Permit Number: 091408

has permission to Change of Use: From warehouse retail to building all with interior renovations.

**Re: Bowl Portland – 58 Alder Street**

Per our discussion, please see our response that is reflected in the construction documents for Bowl Portland:

FT-8040 28 3/4 X 58 3/4 ALUMINUM  
W/. SPRINGS, & RETROFIT FRAME

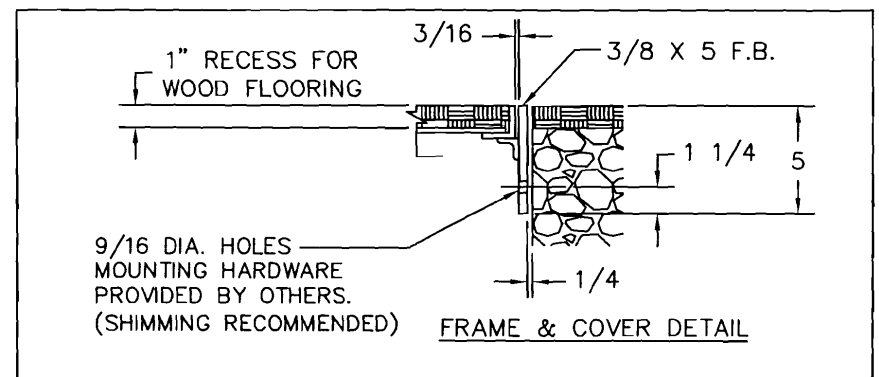
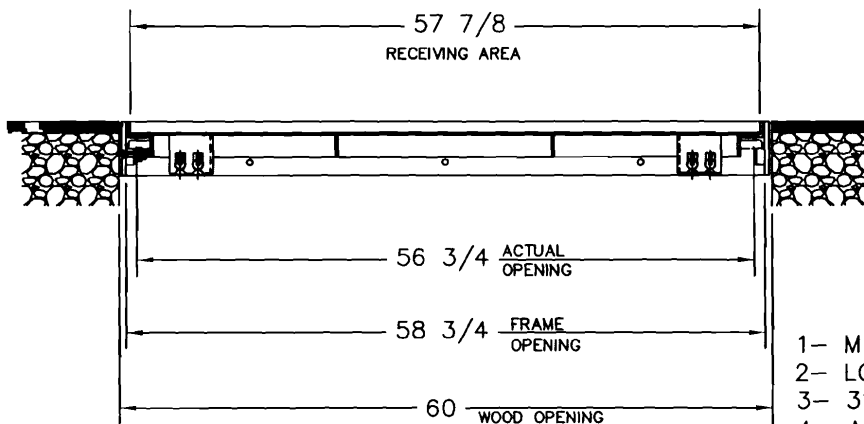
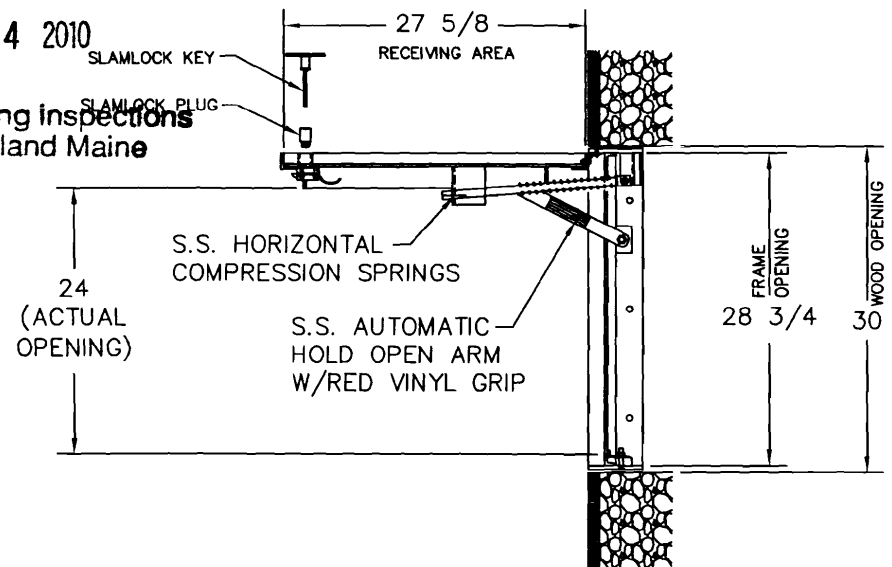
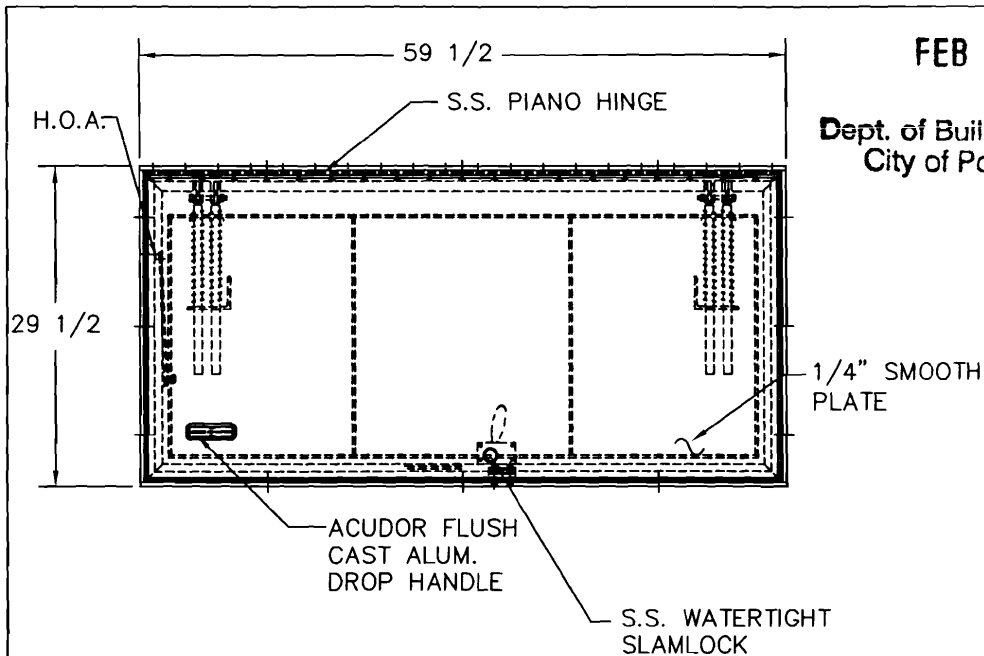
I spoke with Acudor and they forwarded this floor access door that would work for Bowl Portland. The size is not the same but it can be manufactured to our size.

The current stair to the crawl space has 8 ½" risers and 9" treads. There are currently 12 risers and 11 treads. The stair is 3'02" wide. If we maintain an opening of 8'04" minimum we will have head height of 6'08".

Acudor can manufacture an access door that is 3' wide x 8'06" long. This size will allow the stair to remain and still maintain proper head height. The top will be recessed 1/8" to install carpet.

Drawing Title:  
**Proposed  
Floor Plans**

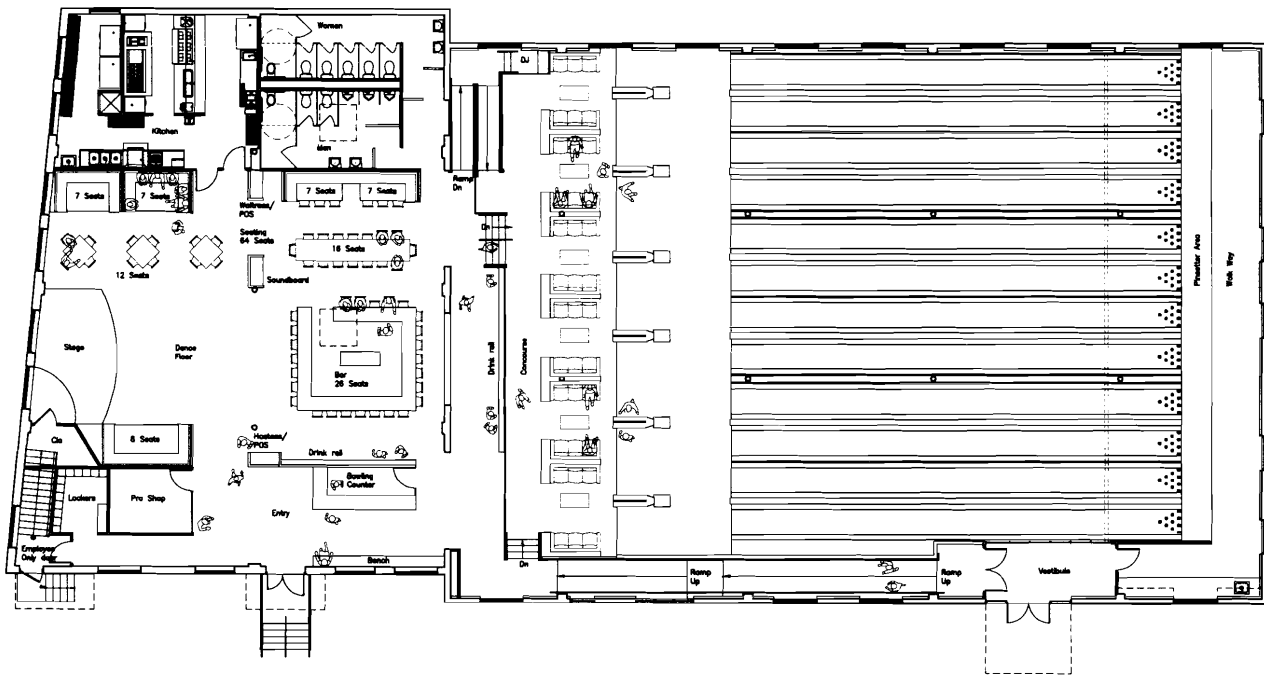
Thank you for meeting with me yesterday to review the Bowl Portland project at 58 Alder Street. The following summarizes our discussion regarding the project and the attached drawing is included for your information:

- The building, within a B-7 zone, is considered a construction type IIIB and an occupancy classification type A-3
- For purposes of reviewing for the Maine State Internal Plumbing Code, the project will be considered a Restaurant, Pub, Lounge. A total occupancy of 467 persons, 3 men's water closets and 2 urinals would be required. 4 Female water closets are required, but the number must be at least equal to men's fixtures, so 5 are required. 3 Lavatories each are required. (Please note that the attached floor plan will be revised per these requirements)
- Type IIIB buildings must have 2-hour rated perimeter bearing walls. The existing building has 3 layers of brick, a total of 12" thick, and meets the required 2-hour rating.
- The building will be fully sprinklered.

Job Number: 09.017  
Date: 14.Sep.09  
Scale: 1/8" = 1'-0"  
Drawing Title:  
Code Review  
Plan

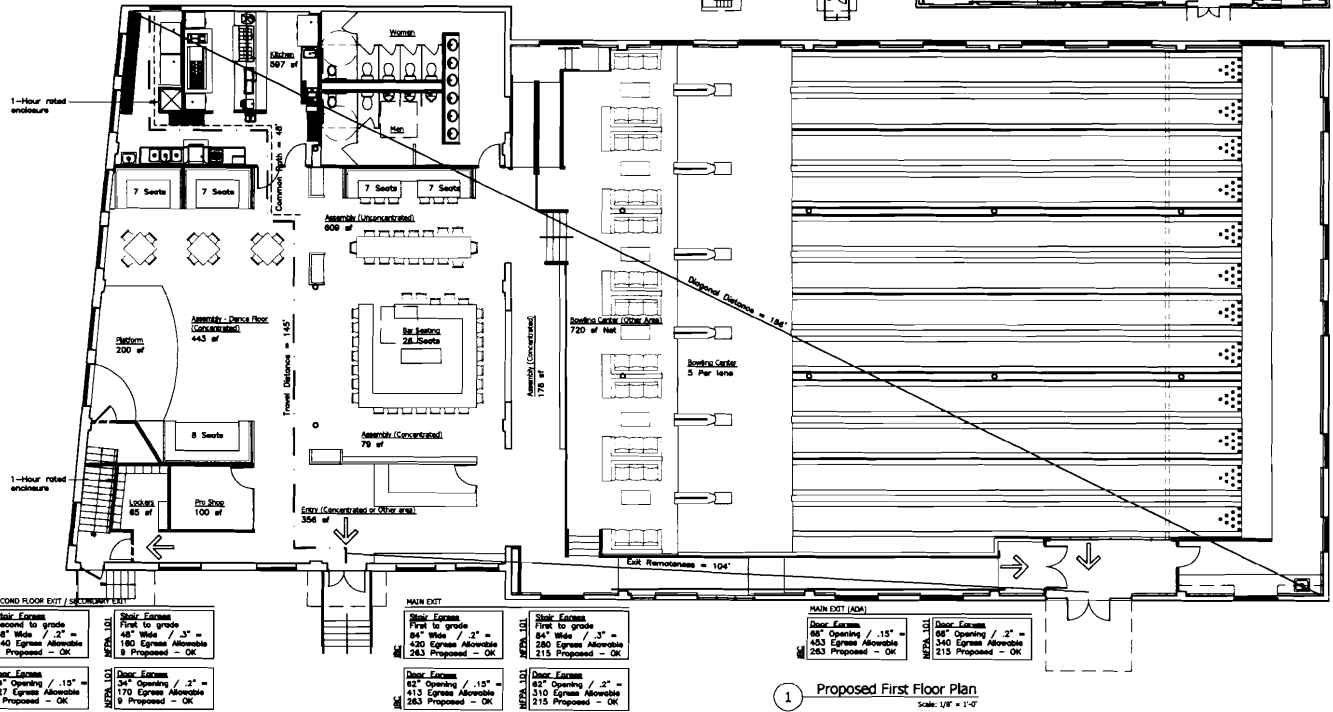
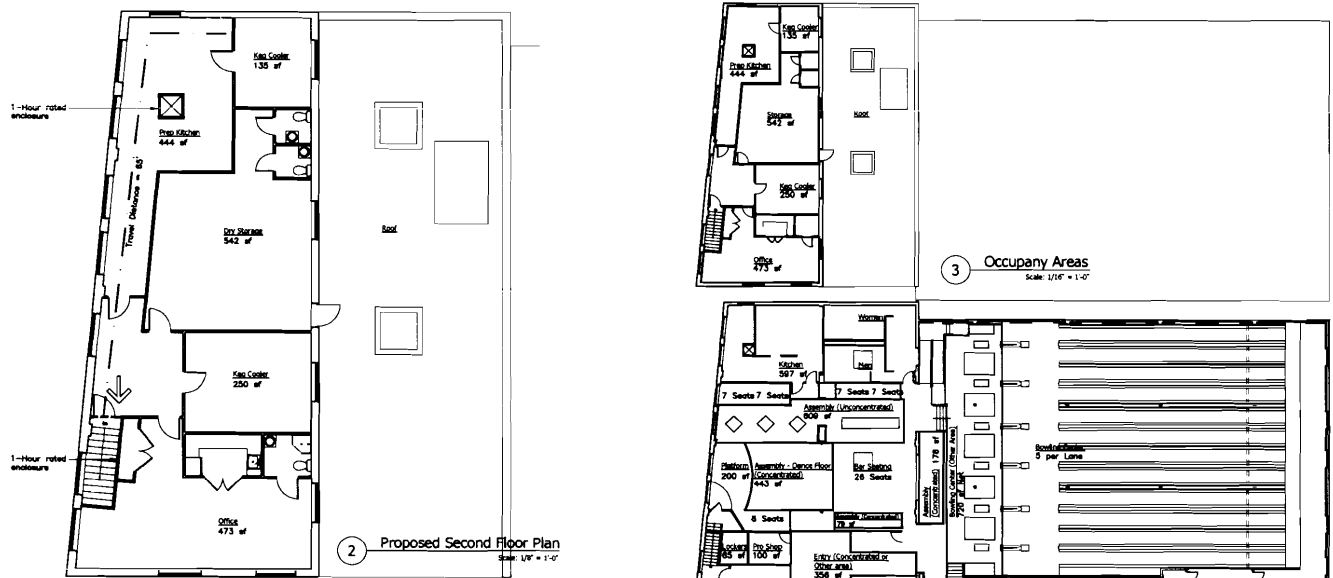
Thank you for meeting with me today to review the Bowl Portland project at 58 Alder Street. The following summarizes our discussion regarding the project and the attached drawing is included for your information:

- The building is considered a construction type III (200) ordinary hazard.
- The building will be fully sprinklered.
- The common path of travel was discussed in detail. New assembly occupancies may only travel 20' on a common path before separate distinct paths are available. The open plan concept is helpful, and the layout of exit signage will be very important so that multiple paths are identified from the bowling center.
- The door to the second floor exit stairway is not necessary as a first floor egress.
- The occupancy load was reviewed and looks acceptable.

ASK.05

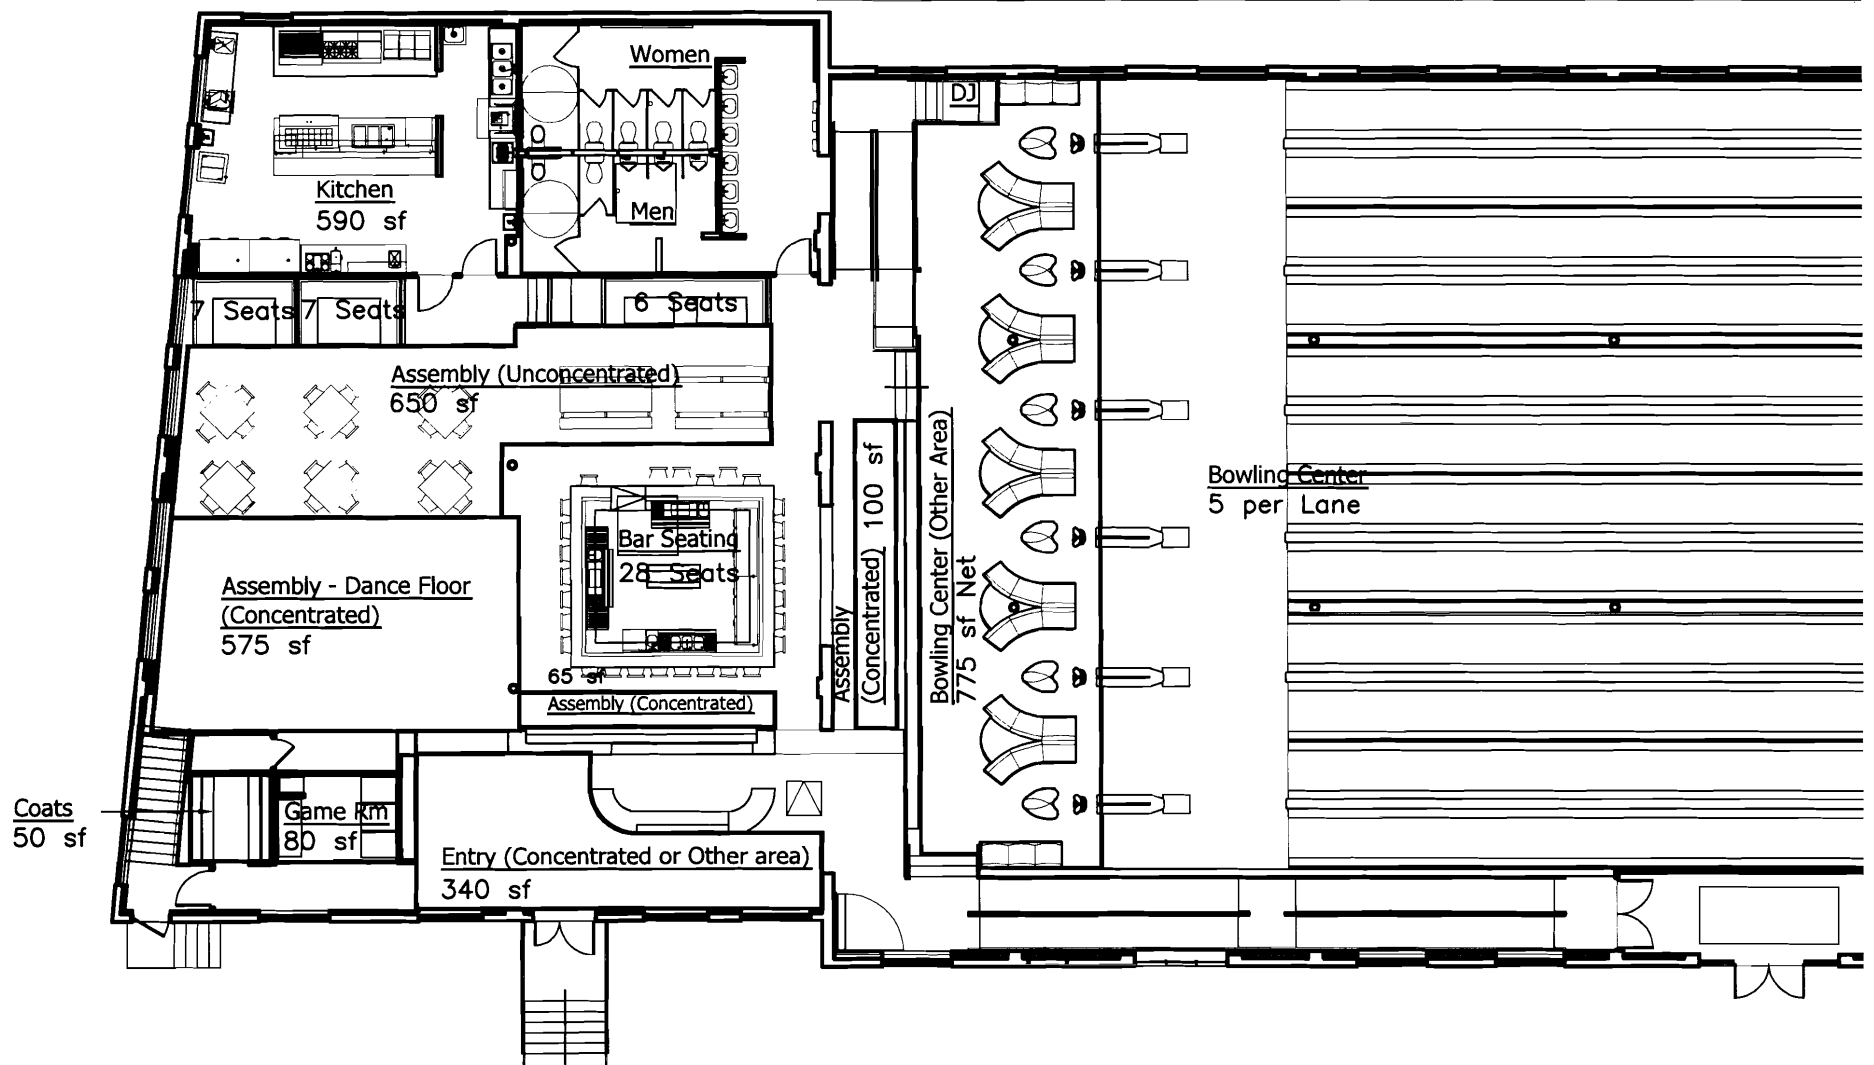
After reviewing your comments regarding ADA accessibility to the stage, the Owner has decided to omit the platform and steps to the platform. It is too late for an addendum, so this will be addressed in change order #1.

By removing the stage, we have been able to re-address the occupant load of the first floor as we have indicated the stage area to be dance floor. See the attached sketches indicating a new occupant load analysis. We have re-addressed the assembly and seating spaces so that there is a total occupant load of 433 on the first floor (NFPA). By factoring 2/3 of egress through the front door, the occupant load through the front door must handle 289 occupants, the door opening can handle 290 occupants. The attached sketches will be issued as change order #1 to the eventual general contractor.
